## **Product Change Notification**

#### PCN-PCC-7355-2021

Business Unit	Product Line Code	Type of Change	Action	Date of Issue
PCC - PCB	AAB	Product Change	Notify Distributors and	11/8/2021
Connectors		Notification	Field

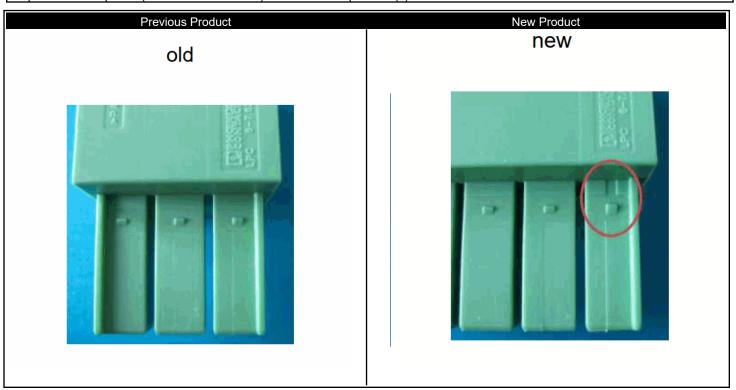
To standardize the insertion and withdrawal forces between small and large numbers of positions, only the latching tabs on the outer positions will be increased. An image for comparison is attached to the PCN. The batch number of the items will be increased. The remaining technical data and external dimensions will not change.
